Change Order Request

PFAS Well 15

Field Order 11- Curb at Generator Area

PROCESS
FIRST FLOOR PLAN

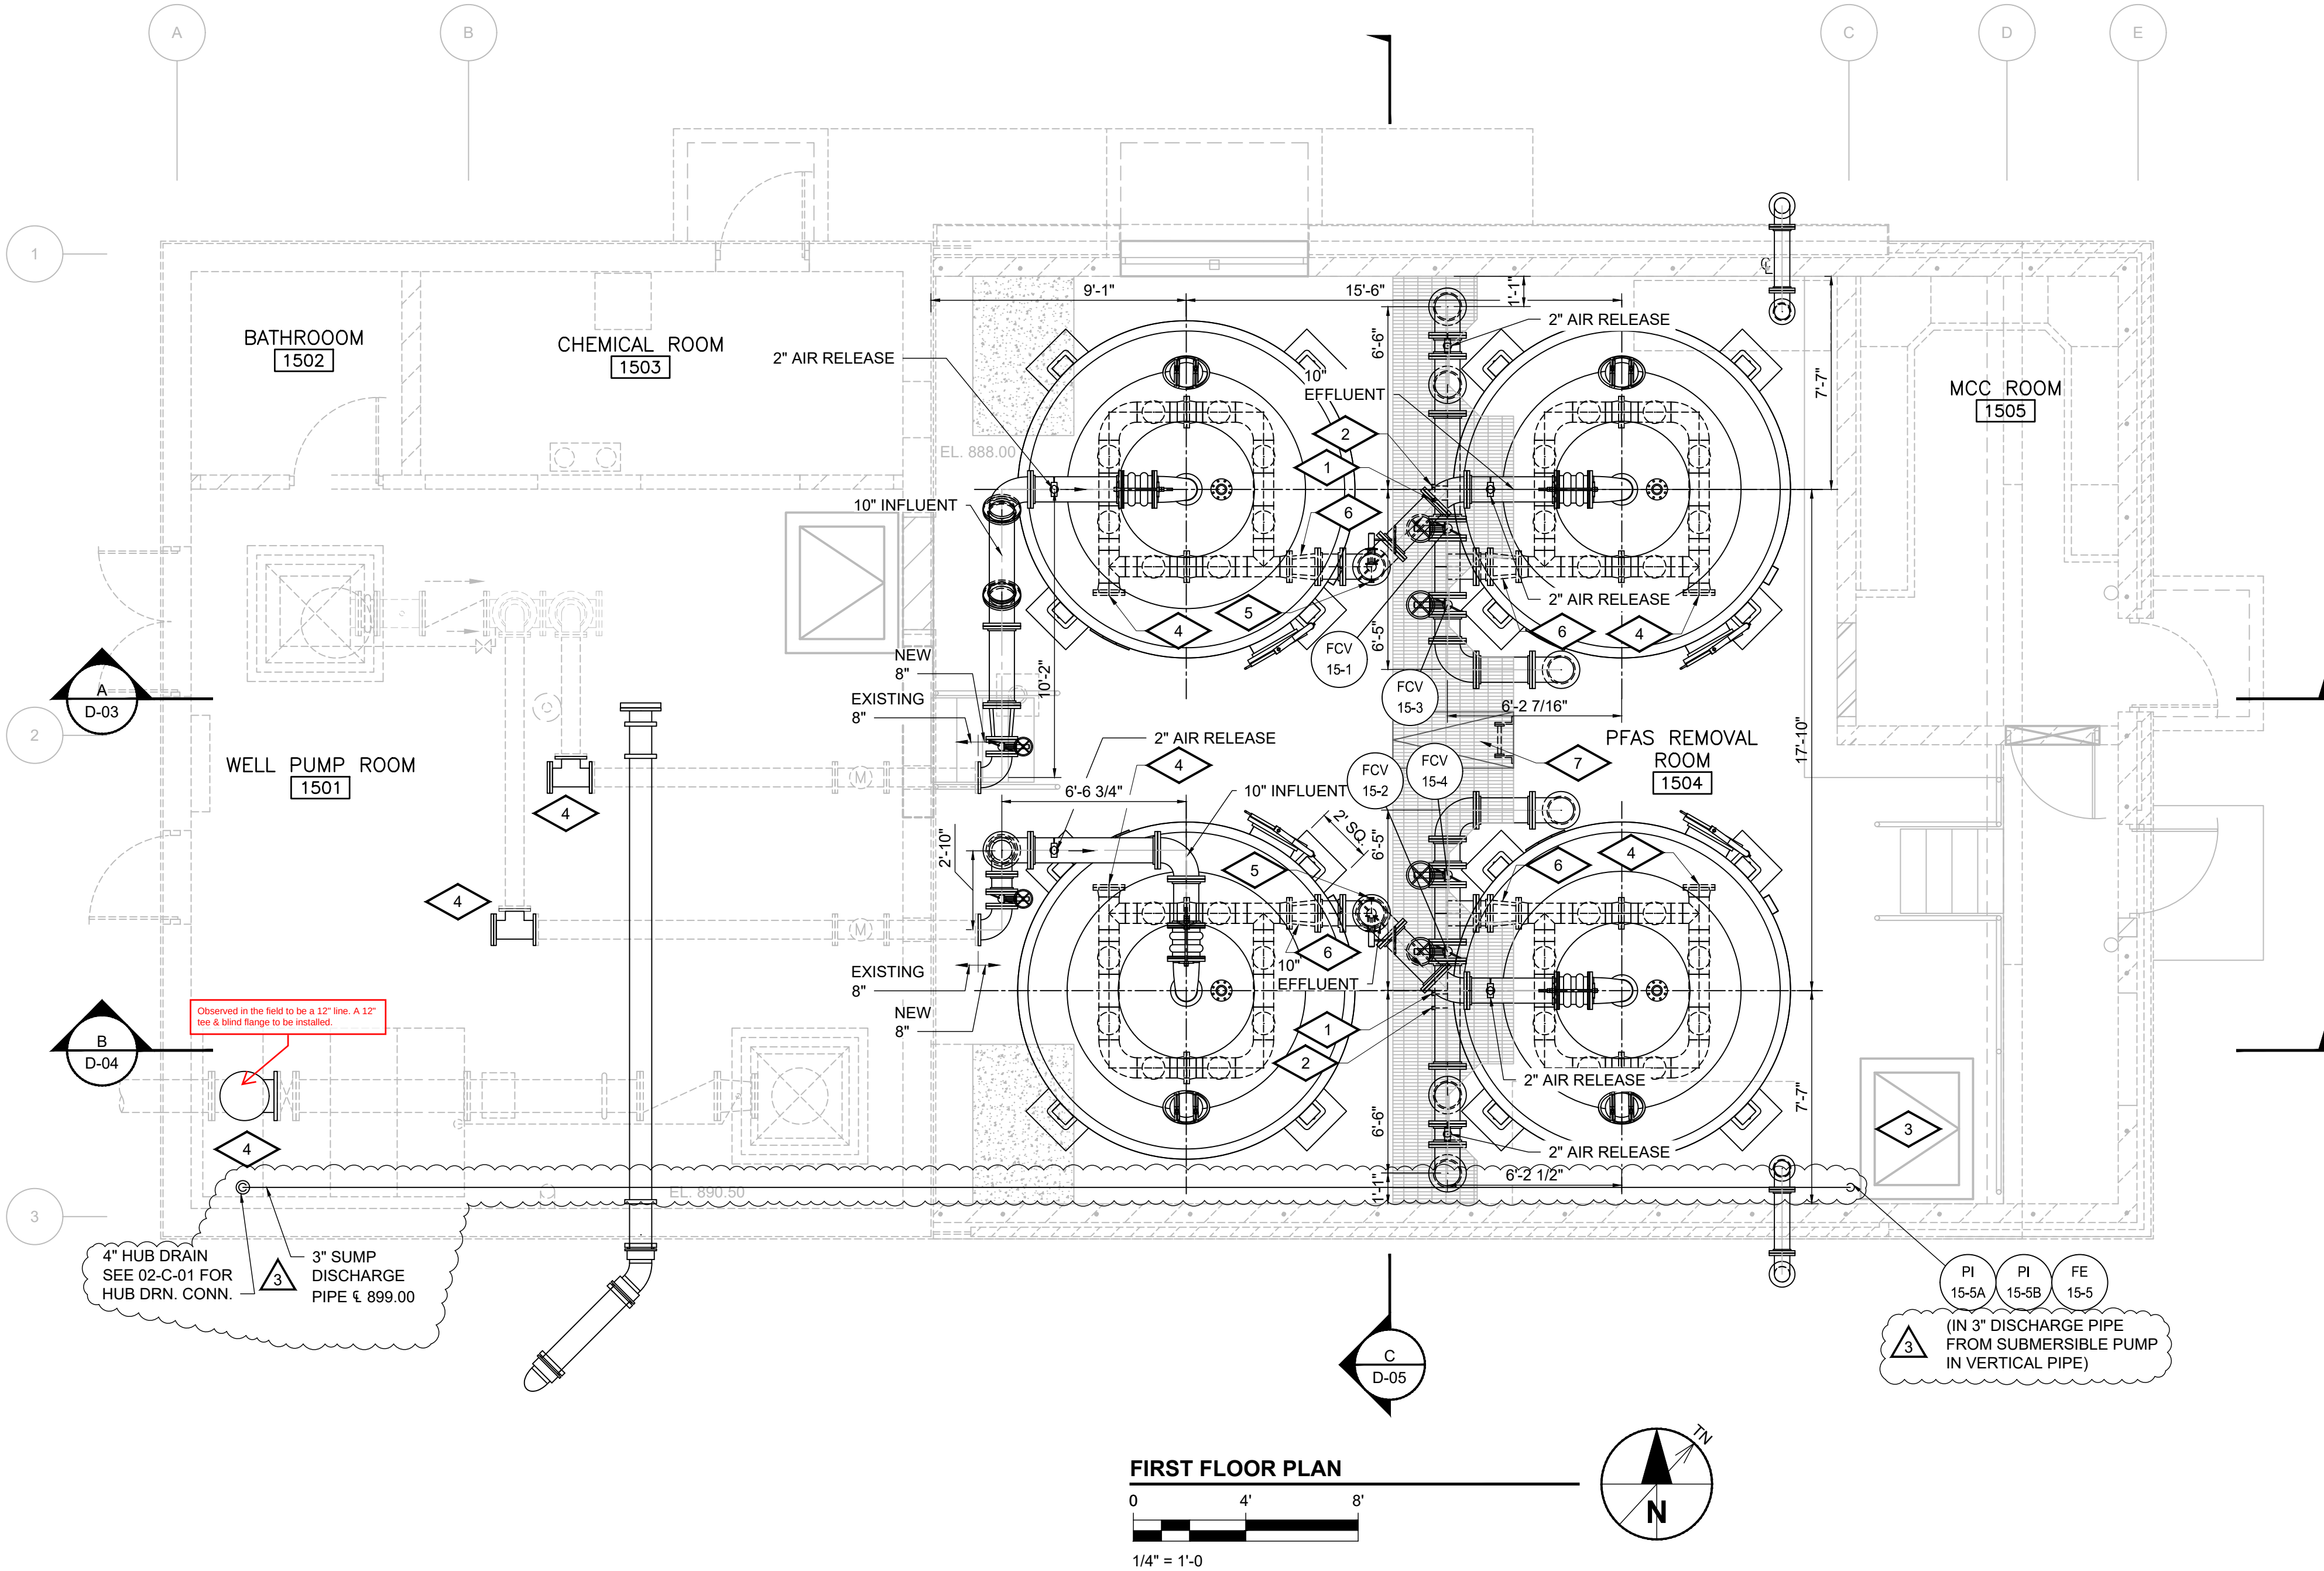
This change order is for the labor, material & equipment to provide one (1) 12" ductile iron tee & one (1) 12" ductile iron blind flange. Sheet(s) 09-N-01 & 09-N-03 note this line to be a 14" size. During install it was observed that the line was 12". New materials were required to match the correct line size. The materials already ordered cannot be sent back to the supplier for a credit. During the installation it was noted that there was blockage at the 12" butterfly valve. The downstream spool was removed to further inspect the debris within the pipe. The debris was removed and the spool was reinstalled with gaskets supplied by MWU. Once the line was commissioned it was observed that the spool was leaking. The contractor provided new gaskets at the spool to stop the leaks and replace the gaskets supplied by MWU.

- 1 CHEMICAL INJECTION POINT
- 2 CHEMICAL INJECTION POINT
- 3 3-INCH LINE FROM SUMP PUMP CAM-LOCK CONNECTION TO HUB DRAIN IN PIPE PIT AT HIGH SERVICE PUMP DISCHARGE. WALL PENETRATION PER DETAILS.
- 4 REPLACE ELBOW WITH TEE AND ADD BLIND FLANGE FOR START UP AND MEDIA REPLACEMENT.
- 5 1" WELDED TAP AND BALL VALVE.
- 6 8"x10" EXPANSION JOINT REDUCER.
- 7 REMOVABLE GRATING FOR ACCESS TO BELOW AND PUMPING OUT THE OVERFLOW CHANNEL.

CIVIL SITE PLAN

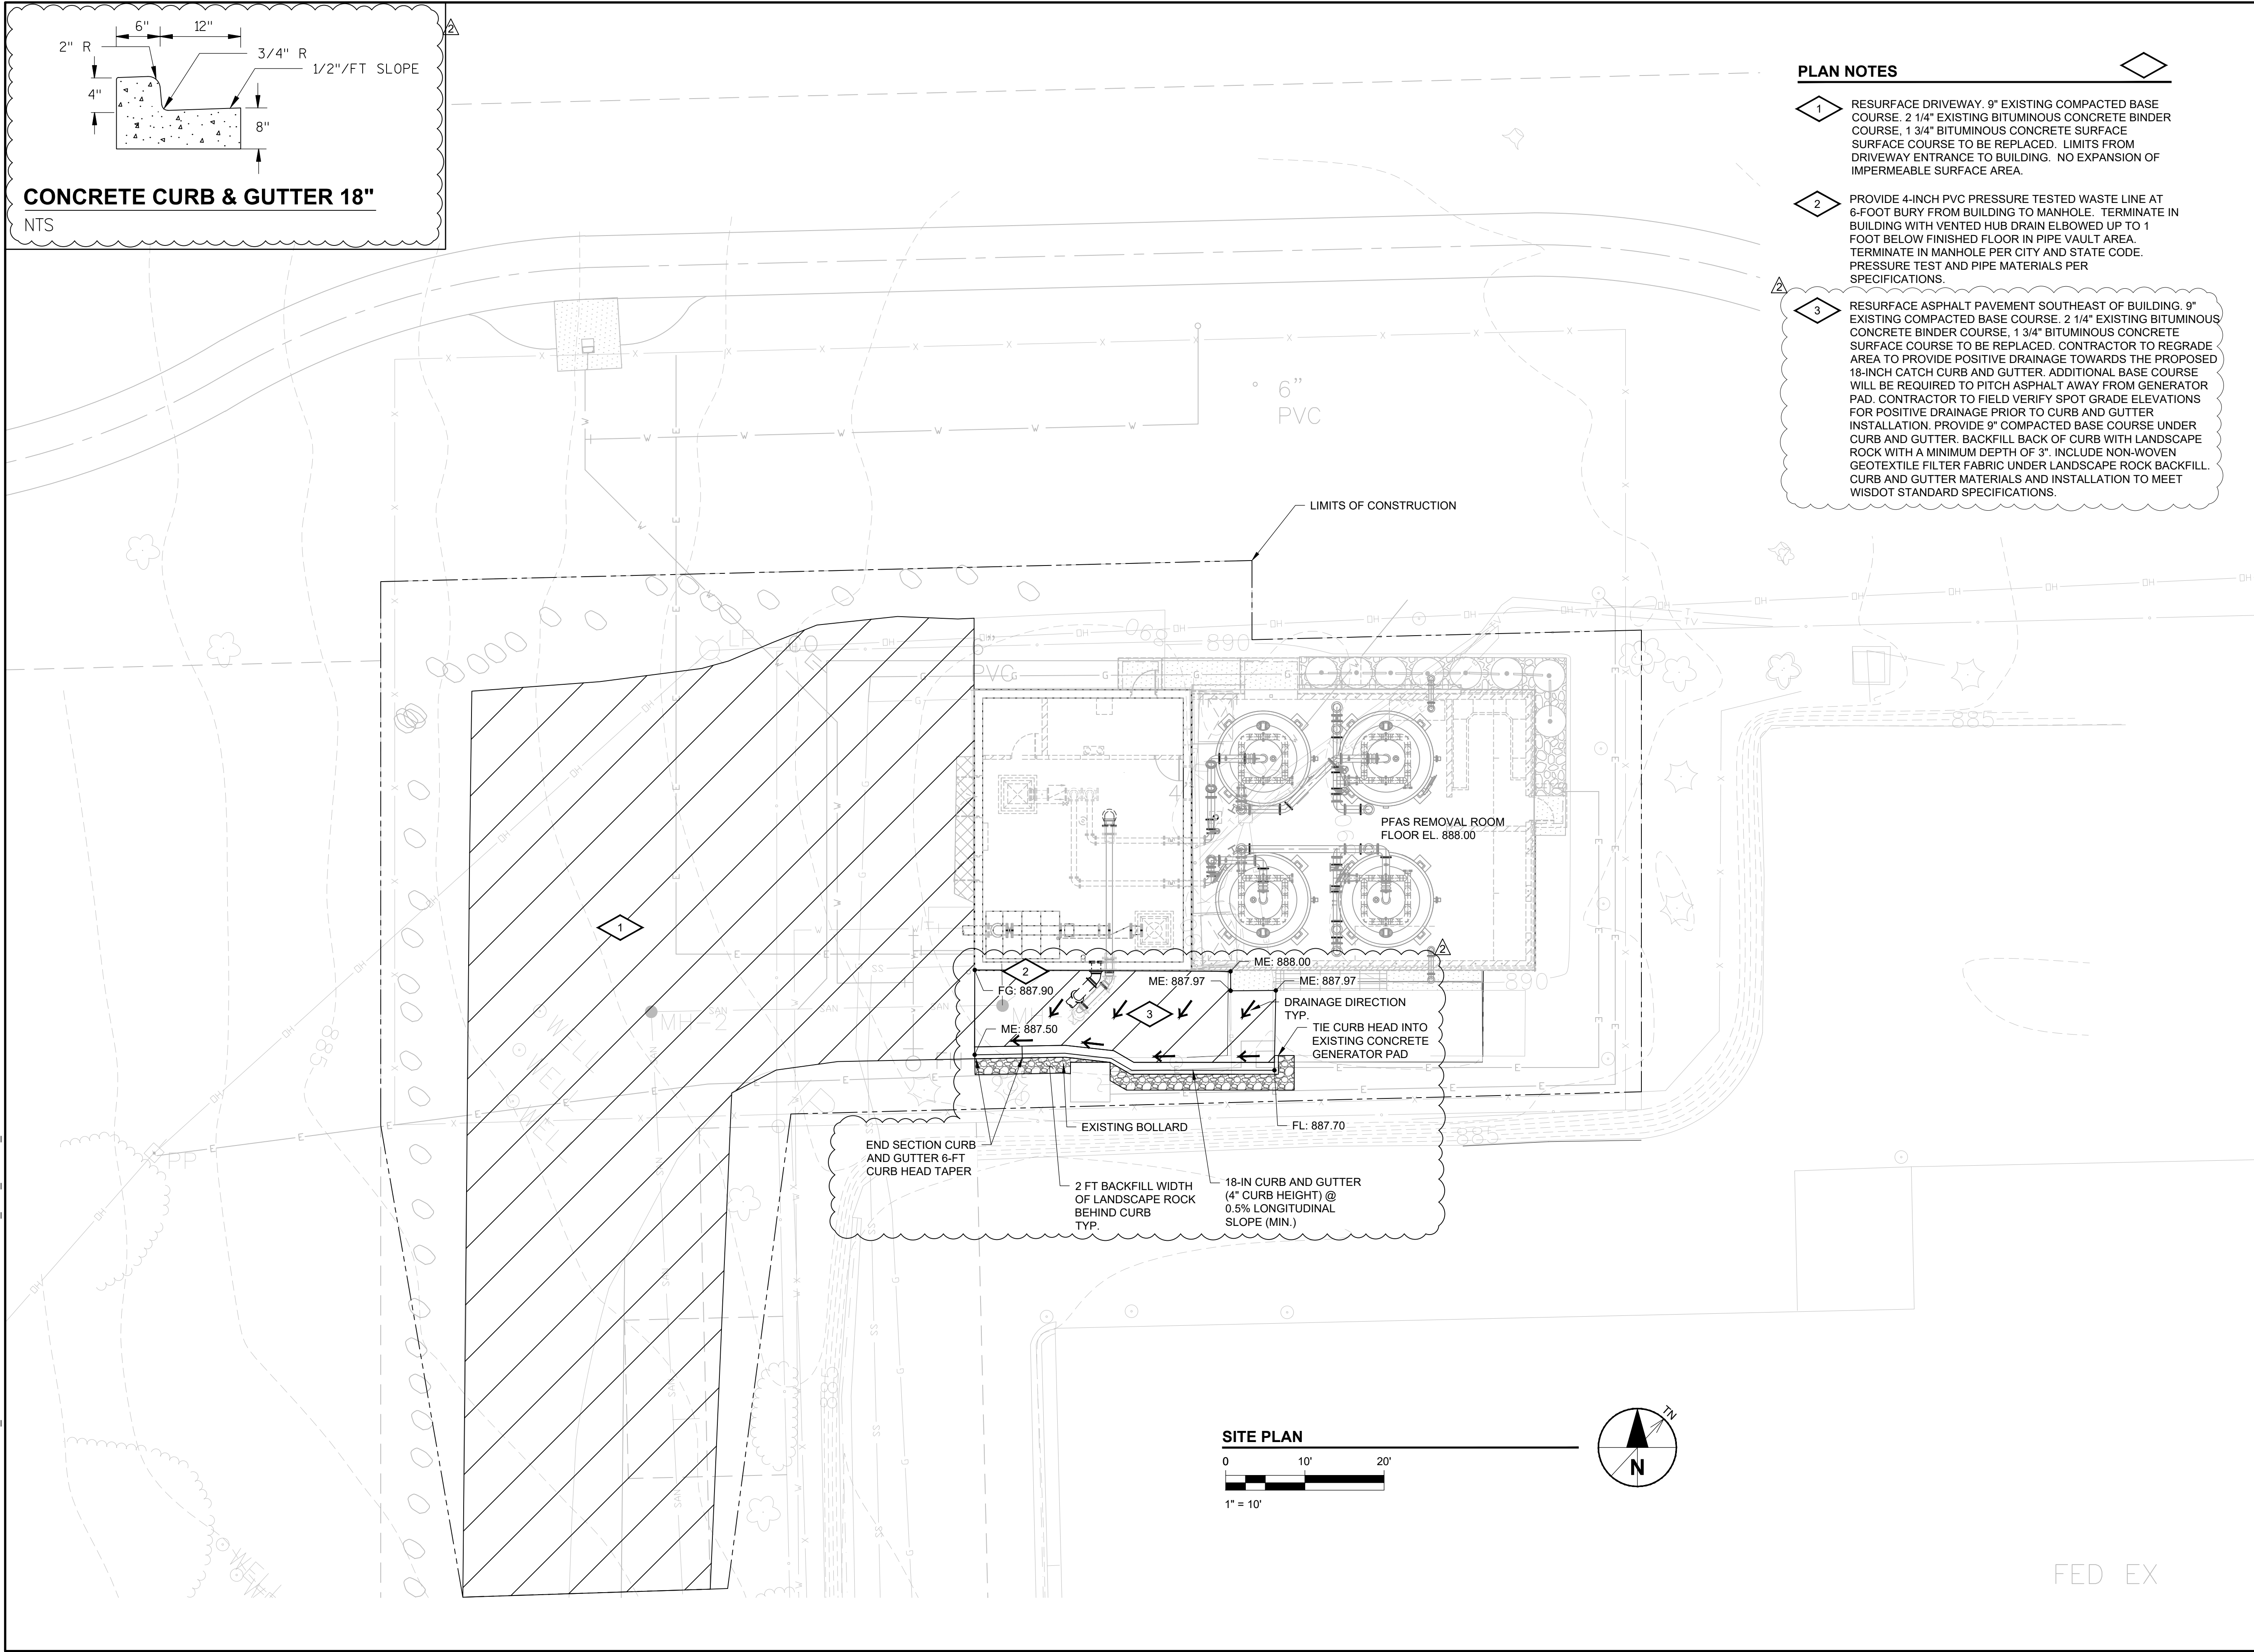
Curb added and additional grading required to slope drainage away from building, generator, and retaining wall.

- 3 RESURFACE ASPHALT PAVEMENT SOUTHEAST OF BUILDING. 9" EXISTING COMPACTED BASE COURSE, 2 1/4" EXISTING BITUMINOUS CONCRETE BINDER COURSE, 1 3/4" BITUMINOUS CONCRETE SURFACE COURSE TO BE REPLACED. CONTRACTOR TO REGRADE AREA TO PROVIDE POSITIVE DRAINAGE TOWARDS THE PROPOSED 18-INCH CATCH CURB AND GUTTER. ADDITIONAL BASE COURSE WILL BE REQUIRED TO PITCH ASPHALT AWAY FROM GENERATOR PAD. CONTRACTOR TO FIELD VERIFY SPOT GRADE ELEVATIONS FOR POSITIVE DRAINAGE PRIOR TO CURB AND GUTTER INSTALLATION. PROVIDE 9" COMPACTED BASE COURSE UNDER CURB AND GUTTER. BACKFILL BACK OF CURB WITH LANDSCAPE ROCK WITH A MINIMUM DEPTH OF 3". INCLUDE NON-WOVEN GEOTEXTILE FILTER FABRIC UNDER LANDSCAPE ROCK BACKFILL. CURB AND GUTTER MATERIALS AND INSTALLATION TO MEET WISDOT STANDARD SPECIFICATIONS.
